Memorandum

To: Megan McKay
From: Benjamin Mark – American Forest Management
Date: 2/9/2022
Re: Site Work Near Retained Trees at the ‘Mercer Island Mixed Use’ Project

2885 78TH AVE SE.
MERCER ISLAND, WA

Lower trunk of Tree #207. Note concrete step to be removed and brick path to remain.

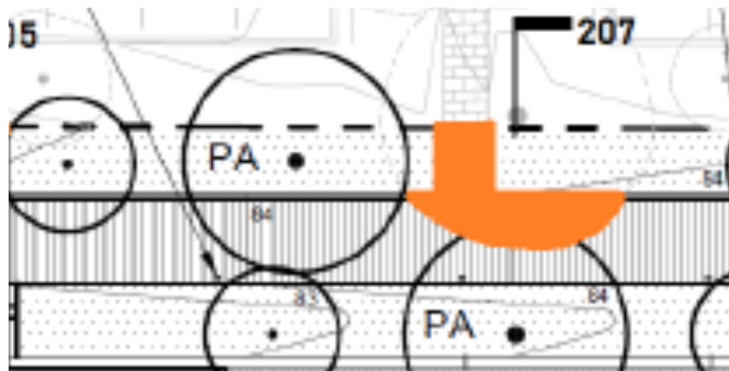
TREE #207 is a ‘Large’ London plane (*Platanus x. acerifolia*) growing near the north property line. This tree has a 23.1 inch DBH and is located near, or possibly on the property line and has large surface roots which are disrupting the walkway and steps immediately to its west. The plan is to remove the existing concrete stairs on the subject property and leave the brick path (right of blue line in photo below) which is on the neighbor’s property in place. No new concrete stairs or ramp is proposed, rather an expansion of the landscape bed.

A six-foot-wide planting area is proposed along the majority of the north property line. Ground disturbance in this area including any trenching for utilities, or compaction caused by heavy equipment traffic or materials storage shall be prohibited in this area. Approximately 60 square feet of pavement removal is proposed within the drip line of Tree #207 as shown in orange on the diagram below.

- Tree protection fencing shall be erected around retained trees and positioned as shown on the attached prior to moving any heavy equipment on site. Doing this will set clearing limits and avoid compaction of soils within root zones of retained trees. Further soil compaction or root disturbance within the drip lines should be avoided to prevent unnecessary damage to the root system.

- Concrete or pavement to be removed from within the driplines of retained trees shall be broken into manageable pieces and removed by hand.
- All work near retained trees must avoid contact from excavator arms or any other equipment with the trunks or branches.

- Any roots that become damaged or broken by heavy equipment must be cut clean with a reciprocating saw to promote occlusion of the wound.
- Any roots which are exposed during demolition or construction should be regularly irrigated to prevent them from drying out until they can be recovered with soil.
